# UNITED STATES PATENT AND TRADEMARK OFFICE

10/581,908

<b>Office Action Summary</b>	<b>Application No.</b> 10/581,908	<b>Applicant(s)</b> KOHCHI ET AL.	
	<b>Examiner</b> David Laux	<b>Art Unit</b> 4193

## **DETAILED ACTION**

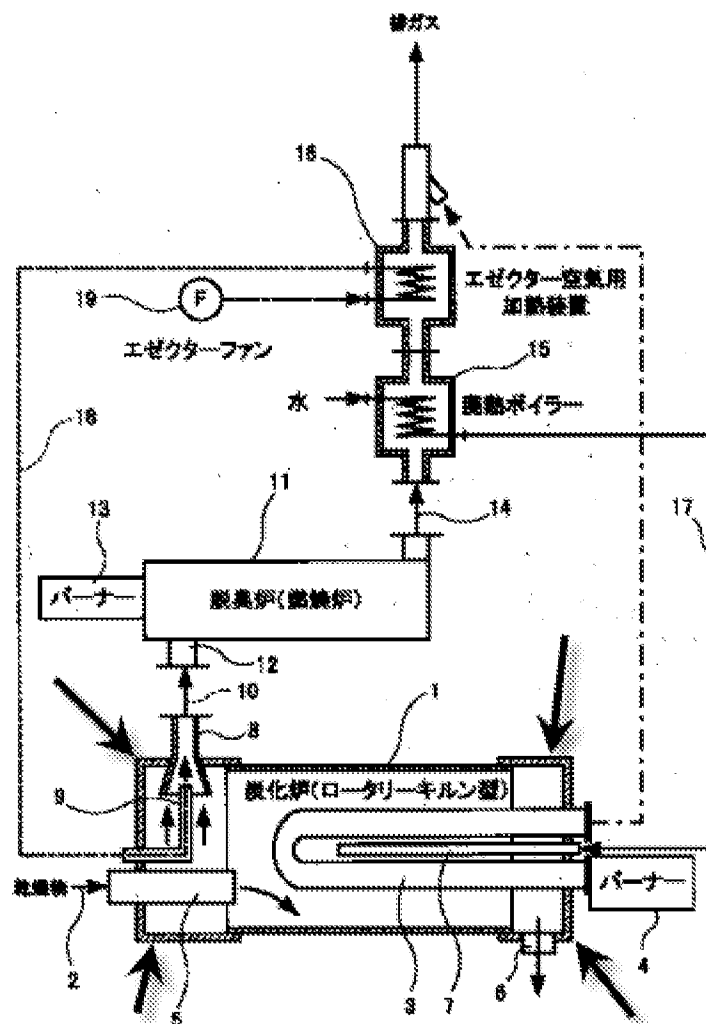
2. Claim 13 is rejected under 35 U.S.C. 103(a) as being unpatentable over JP

2002-364816 to Osamu et al in view of JP 2002-194362 to Susumu et al. '816

discloses a carbonization apparatus which comprises: a drying carbonization furnace

(1) for drying waste material (2) by heat transmission caused by bringing said waste

material (2) into direct contact with overheated steam introduced thereinto to carbonize

said waste material and discharging spent steam which is no longer required; a

deodorizing furnace (11) for deodorizing impurities contained in the spent steam

discharged from said drying carbonization furnace (1) by heating the steam and

discharging the steam reaching a high temperature; and a waste heat boiler (15) for

generating steam from water heated with the high-temperature steam discharged from

said deodorizing furnace (11).

3. '816 fails to disclose a high-temperature steam generator for generating, from the

steam introduced therein, the overheated steam to be fed to said drying carbonization

furnace. '362 teaches a carbonization apparatus with a high-temperature steam

generator (2) for generating, from the steam introduced therein, the overheated steam

to be fed to a drying carbonization furnace (3). It would have been obvious to one

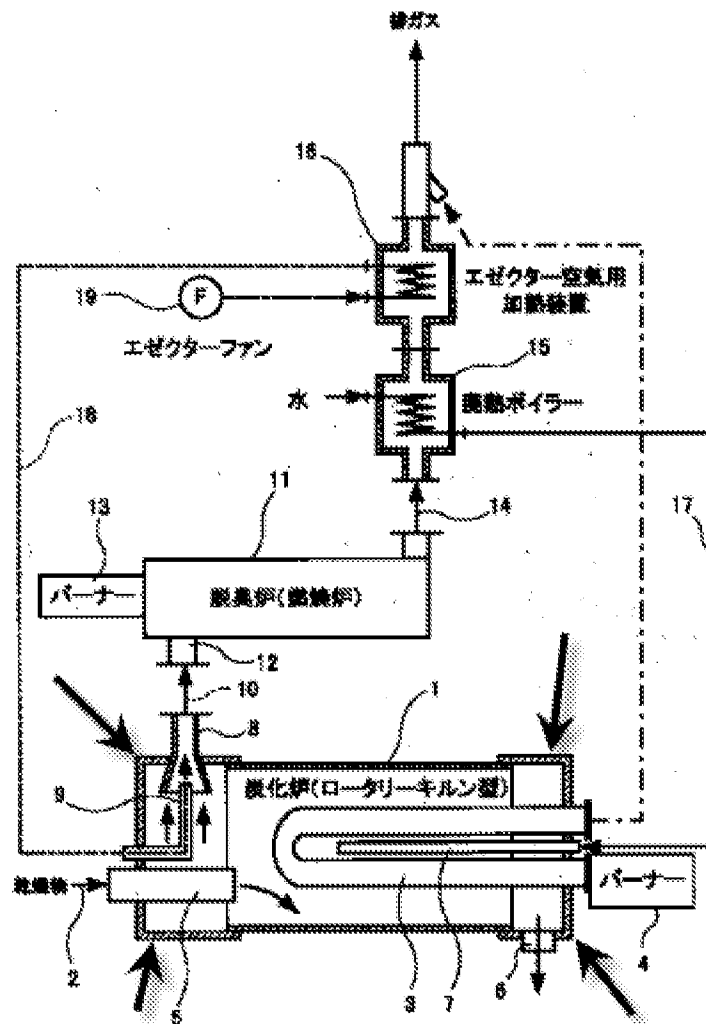
6. Claims 14-17, 20 and 23 are rejected under 35 U.S.C. 103(a) as being unpatentable over '816 in view of '362 as applied to claim 1 above, and further in view of JP 55003510 to Nagao. '816 further discloses a drying carbonization furnace provided with a cylinder shell (represented by arrows in Fig. reproduced below; hereafter "arrow") having a waste intake port (5) for introducing waste material (2) to be treated, a cylinder part (1) for stirring and moving the waste material, an exhaust port (6) for discharging the waste material, and a steam inlet port (7) for introducing overheated steam or spent steam tangentially from the outside of said cylinder part (1) to the inside of said cylinder part (1), wherein said cylinder shell (arrow) is provided with a plurality of steam inlet ports (7, each hole from which steam can be released is a port), wherein said cylinder shell (arrow) is provided with a steam discharge port (8) from which the spent steam after heating the waste material (2) in said cylinder shell (arrow) is discharged in a direction tangent to the inner surface of said cylinder part (1) from the inside of said cylinder part (1) to the outside of said cylinder part.

7. '816 fails to disclose rotatable stirring blades for stirring and moving the waste material in said cylinder shell, wherein a steam inlet port is formed to introduce the overheated steam or spent steam in the same direction tangent to the inner surface of said cylinder as the rotation direction of said stirring blades. '510 teaches a rotary carbonization furnace with stirring blades (9, 10) for stirring and moving waste material in a cylinder shell. The steam inlet port (7) of '816 is formed such that it introduces the overheated steam in the same direction tangent to the inner surface of said cylinder as

the rotation direction of said stirring blades. It would have been obvious to one skilled in the art at the time of invention to modify the carbonization furnace of '816 with the stirring blades of '510 because such a combination would have produced the added benefit of a more thoroughly carbonized end product.

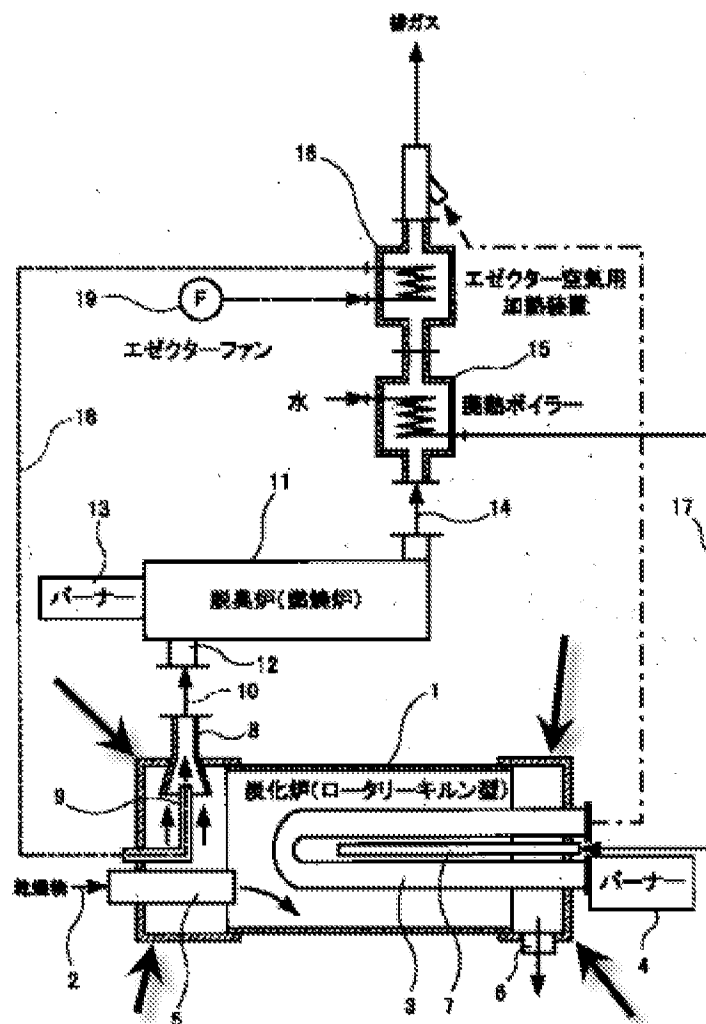
8. Claims 28-31, 34 and 37 are rejected under 35 U.S.C. 103(a) as being unpatentable over '816 in view of '362 and '479 as applied to claim 27 above, and further in view of JP 55003510 to Nagao. '816 further discloses a drying carbonization furnace provided with a cylinder shell (represented by arrows in Fig. reproduced below; hereafter "arrow") having a waste intake port (5) for introducing waste material (2) to be treated, a cylinder part (1) for stirring and moving the waste material, an exhaust port (6) for discharging the waste material, and a steam inlet port (7) for introducing overheated steam or spent steam tangentially from the outside of said cylinder part (1) to the inside of said cylinder part (1), wherein said cylinder shell (arrow) is provided with a plurality of steam inlet ports (7, each hole from which steam can be released is a port), wherein said cylinder shell (arrow) is provided with a steam discharge port (8) from which the spent steam after heating the waste material (2) in said cylinder shell (arrow) is discharged in a direction tangent to the inner surface of said cylinder part (1) from the inside of said cylinder part (1) to the outside of said cylinder part.

9. '816 fails to disclose rotatable stirring blades for stirring and moving the waste material in said cylinder shell, wherein a steam inlet port is formed to introduce the overheated steam or spent steam in the same direction tangent to the inner surface of said cylinder as the rotation direction of said stirring blades. '510 teaches a rotary carbonization furnace with stirring blades (9, 10) for stirring and moving waste material in a cylinder shell. The steam inlet port (7) of '816 is formed such that it introduces the overheated steam in the same direction tangent to the inner surface of said cylinder as

the rotation direction of said stirring blades. It would have been obvious to one skilled in the art at the time of invention to modify the carbonization furnace of '816 with the stirring blades of '510 because such a combination would have produced the added benefit of a more thoroughly carbonized end product.
